37/03-06CC 515 New York Ave  
Takoma Park Historic District, 37/03

**HISTORIC PRESERVATION COMMISSION STAFF REPORT**

**Address:** 515 New York Avenue, Takoma Park      **Meeting Date:** 06/21/06  
**Resource:** Contributing Resource      **Report Date:** 06/14/06  
                  **Takoma Park Historic District**  
**Review:** HAWP      **Public Notice:** 06/07/06  
**Case Number:** 37/03-06CC      **Tax Credit:** Partial – front porch floor  
**Applicant:** Carole Crandon (Yerko Pallominy, Agent)      **Staff:** Michele Oaks

**PROPOSAL:** Alterations

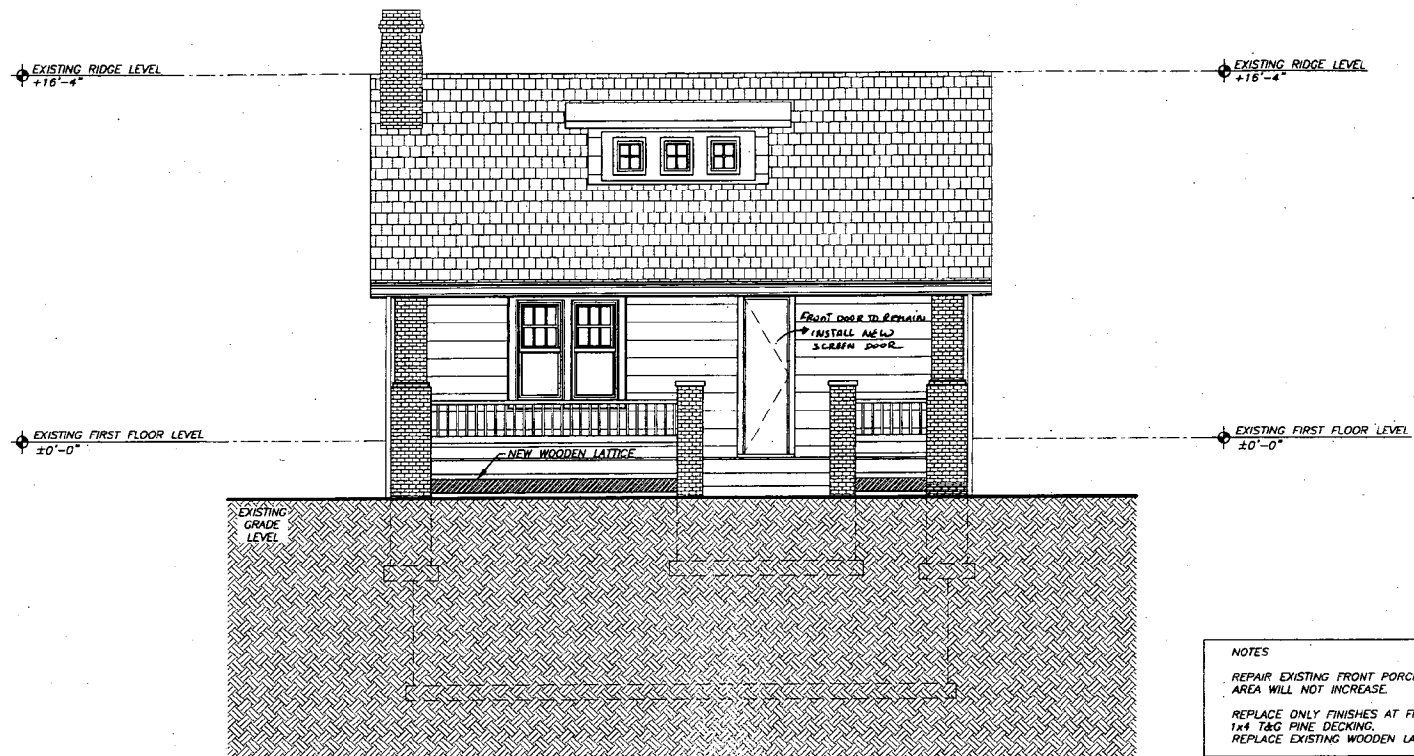
② specs for rear +  
front screen ~~door~~

③ description: oak tag  
dwgs = pine tag

④ specs for windows

# FRONT PORCH

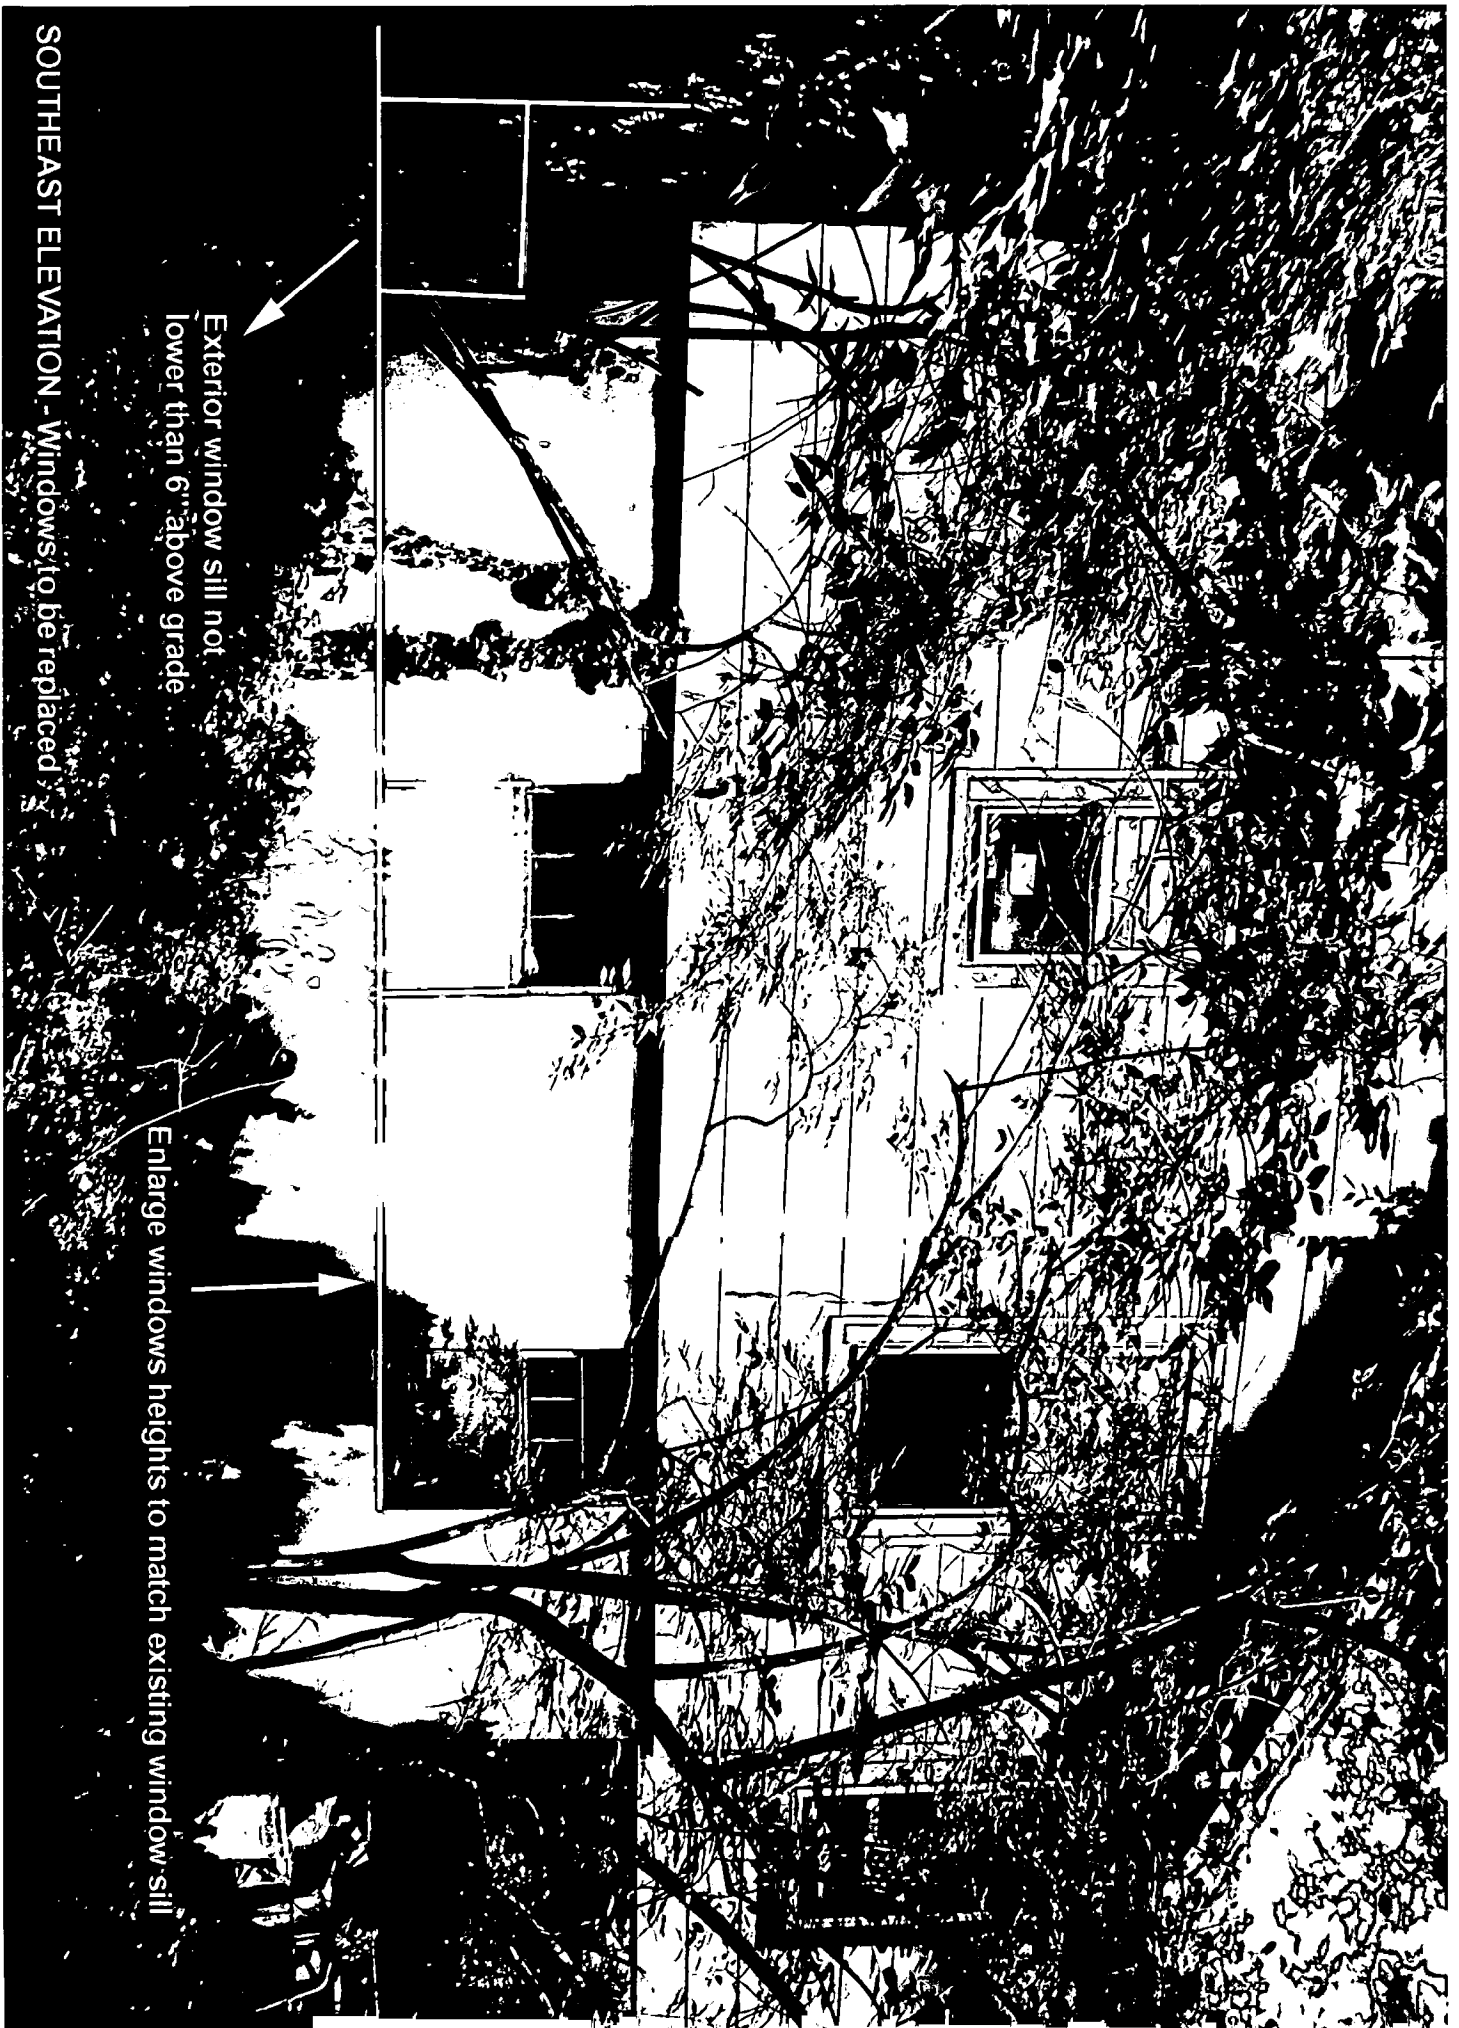
3. The wood lattice panels to be installed underneath the front porch, will be constructed with wood frames, and installed as separate panels. The detail will be included in the permit sets of drawings submitted to staff at the time of stamping.

5. The applicant's front porch floor will be replaced with painted or stained, oak, tongue and groove flooring.
